DESIGN REVIEW COMMITTEE MEMORANDUM

SUBJECT: File No.: **ADR20-0069**; Razmara SFD
Applicant: Neal Schwartz
Address: 4042 Pepperwood Court Sonoma, CA
APN(s): 064-010-013

DESIGN REVIEW COMMITTEE RECORD OF ACTION

ATTENTION > Derik Michaelson, Derik.Michaelson@sonoma-county.org
> Hannah Spencer, hannah.spencer@sonoma-county.org
> Joshua Miranda, joshua.miranda@sonoma-county.org
REGARDING > **DRC RECORD OF PROPONENT ACTION RESPONSE**
PROJECT > 4042 Pepperwood Court | APN: 064-010-013
DATE > 2021 05 28

4042 PEPPERWOOD COURT: REVISED SITE PLAN PROPOSAL PER DRC REVIEW AND COMMENTS

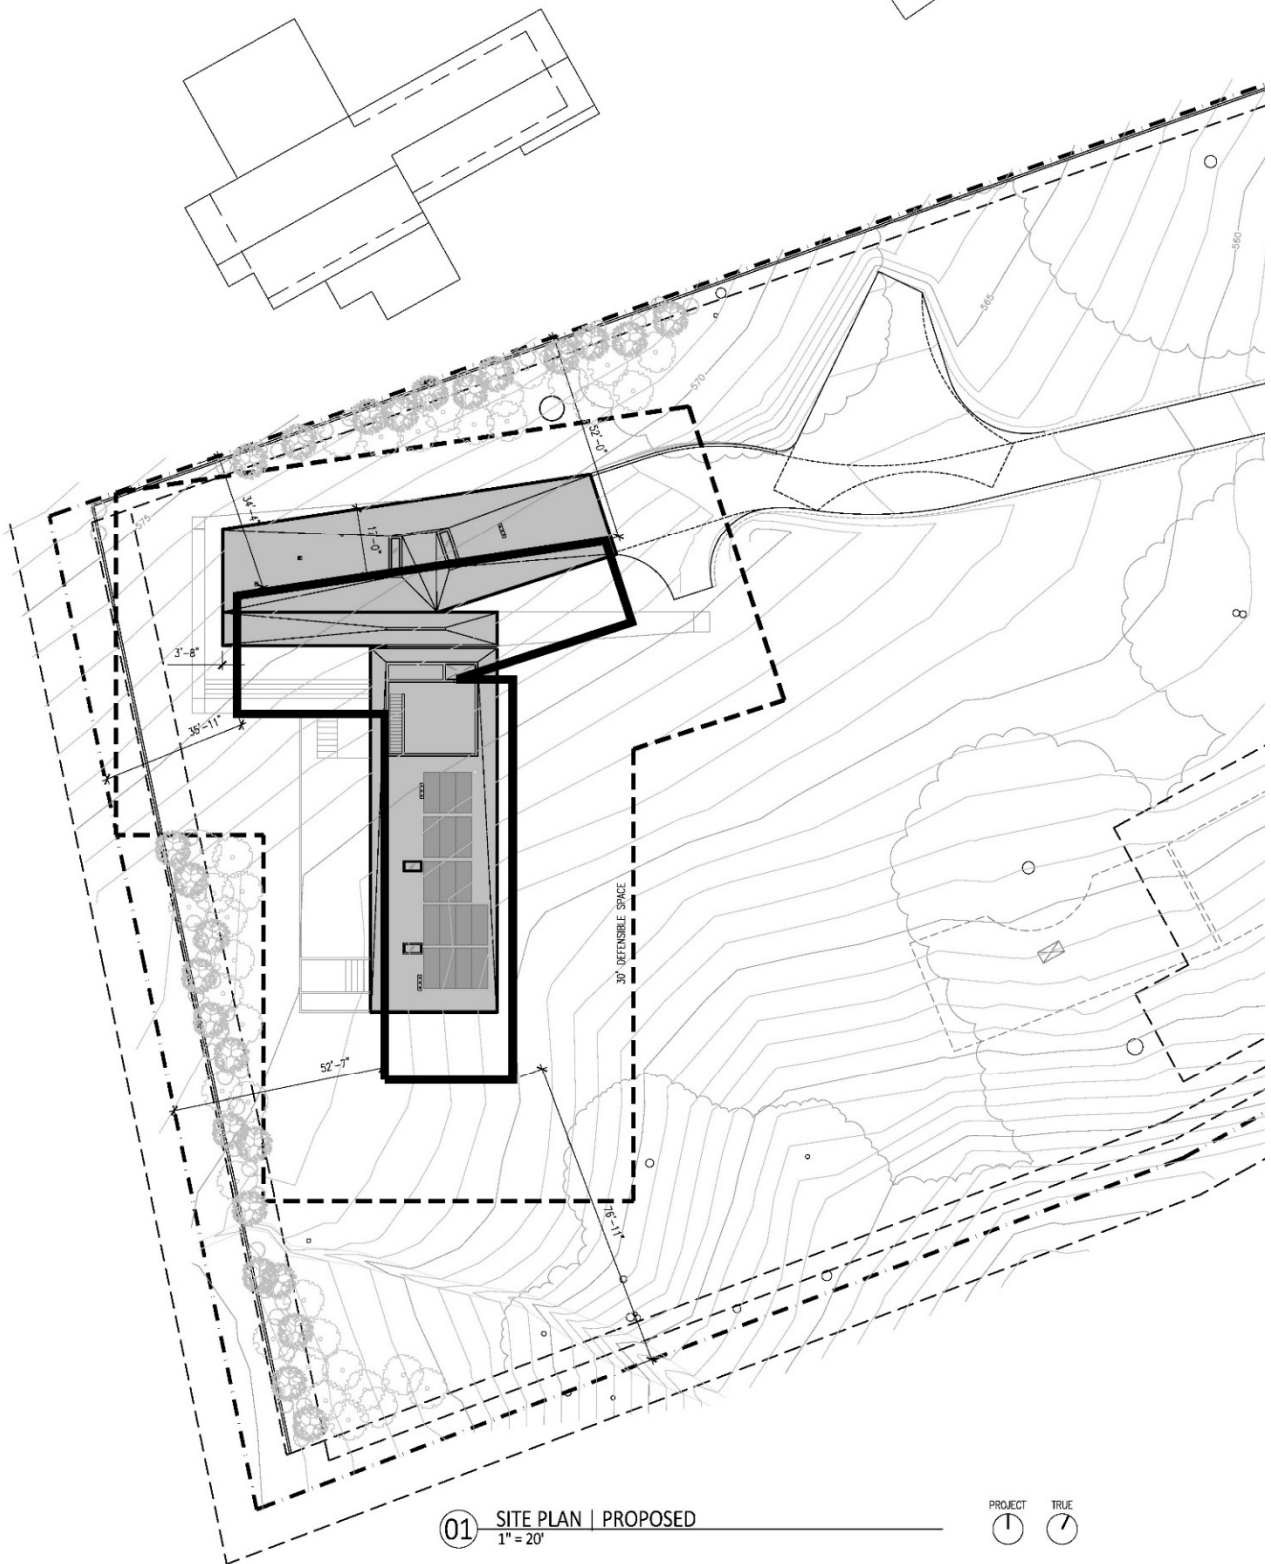
2. Adjust the footprint location of the home to provide further separation from the rear and side lot lines for additional screening opportunities and to maintain within the property lines a sufficient boundary of defensible space around the home.

5. Modify the row-design of screen trees shown along the rear and side property lines to reflect a more natural looking planting pattern

Revised Proposal (see site plan diagram):

- > This is a tangible criterion whose value we can all understand and which we believe creates a solid professional, objective, and logical foundation for the Committee's approval. It is shown by the thick dashed line.
- > We have set this defensible space boundary so that its North and West edges touch the property line.
- > The resultant shifts the building 17' to the South, 7' beyond the original DRC directive and clearly within the revised directive to study moving south between 10'–20'.
- > The building moves to the East 3' 8" as the result of the shift south, also directly responding to the Committee's request to move the building further from the property line.

- > The trees on our ADR site plan were intended as a graphic to communicate the potential for landscape screening where desired. We have modified this landscape screening along the rear and side property lines to reflect a more natural planting pattern. In addition, we increase planting density where privacy is of most concern, outside the perimeter of the proposed voluntary 30' defensible space setback.
